Meeting Agenda

Franklin Municipal Planning Commission

Thursday, April 23, 2020

4404 PEYTONSVILLE ROAD SUBDIVISION, FINAL PLAT
FRANKLIN MUNICIPAL PLANNING COMMISSION
4/23/2020

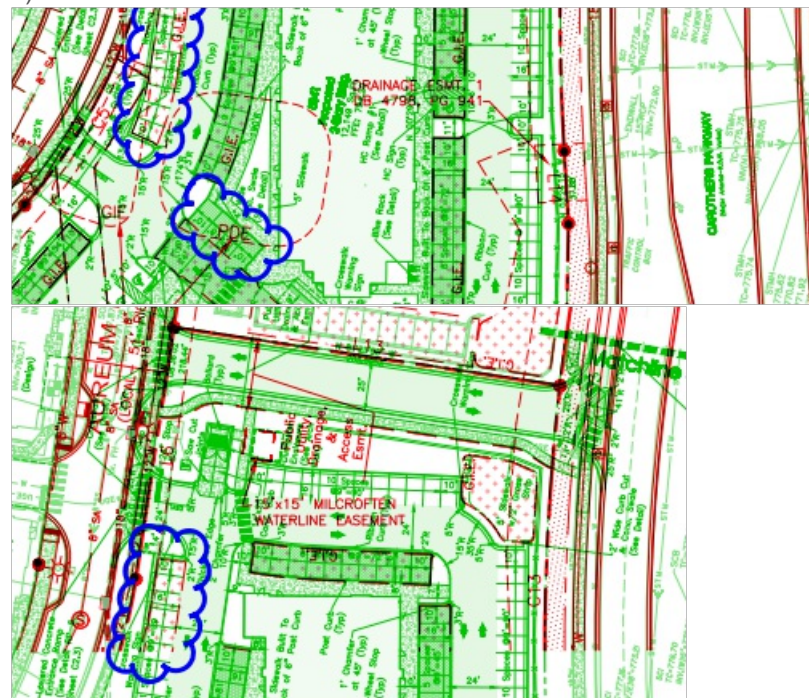
joe.marlo@franklin.tn.gov Comment partially addressed, however easements on the Site Plan have changed since the previous submittal and the changes have not been picked up on the Final Plat.

Applicant shall ensure that any changes to the Carothers Crossing West Section 2 Site Plan (COF 7198) which is being reviewed concurrently with this Final Plat, are reflected on the Final Plat. The Final Plat shall match the Site Plan, including the following items:

1. Applicant shall revise the easements around the transit stop to be a Public Utility Drainage and Access Easement. (Sheet 3)

2. Applicant shall correct the extents of the GIE easements clouded in blue below. (Red - submitted plat; Green - latest Section 2 Site Plan submittal) (Sheets 3 and 4)

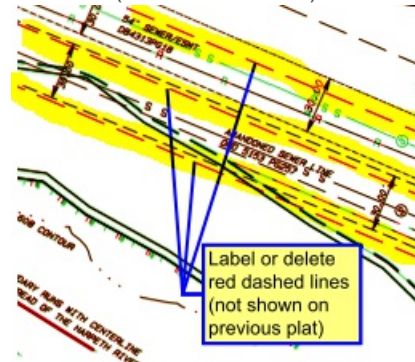
2. Show the missing easement line noted below from the previous plat (green) (Sheets 1 and 2).

3. Label Lots 100 and 101 as 'Public Utility Drainage and Access Easements' (PUDAE) (Sheets 1 and 2).

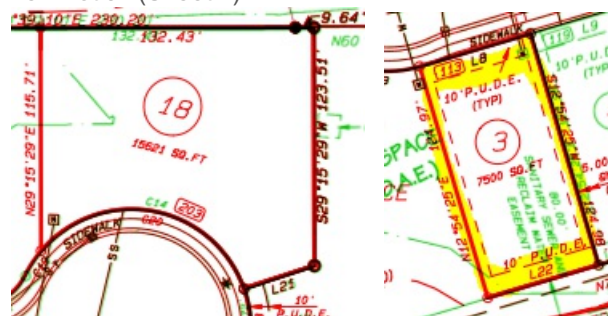
4. Show the SS line and manholes noted below (green) (Sheets 2 and 3).

5. Label (or delete if errant) the new dashed lines noted below (red) (Sheets 2 and 3)

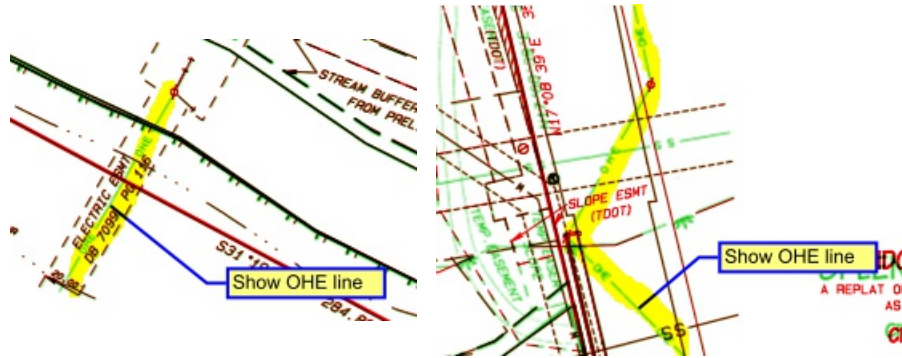
6. Show and label the PUDE's around sides of new Lot 18, similar to that shown for new Lot 3. (Sheet 2)

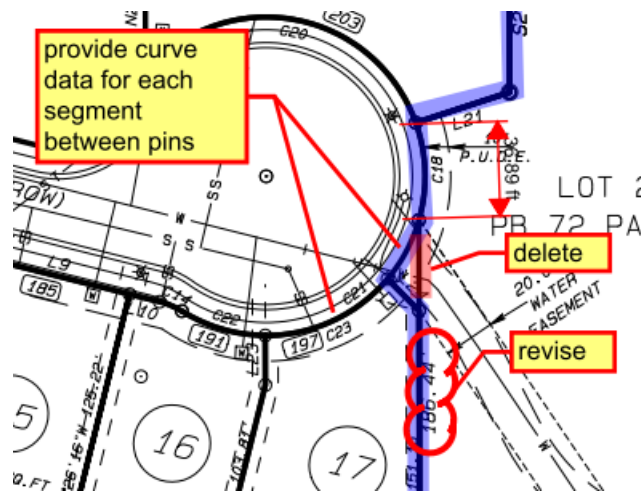
7. Show the OHE lines noted below (green) (Sheet 3).

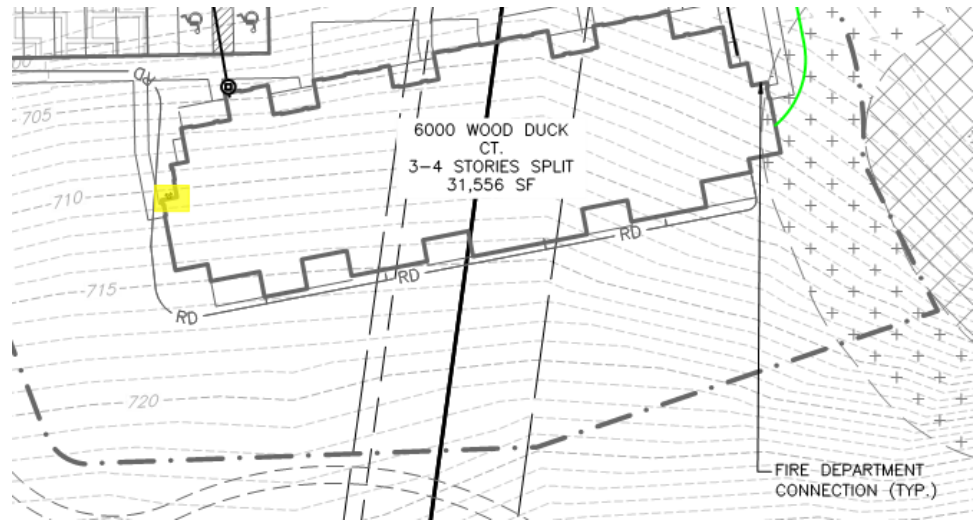
curt.edelmann@franklintn.gov This comment would normally come up on the review of the fire underground drawings, but I thought I should mention it here because you may need to relocate pipe.

Sectional valves are required in a fire underground line so that no single section serves more than six fire services.
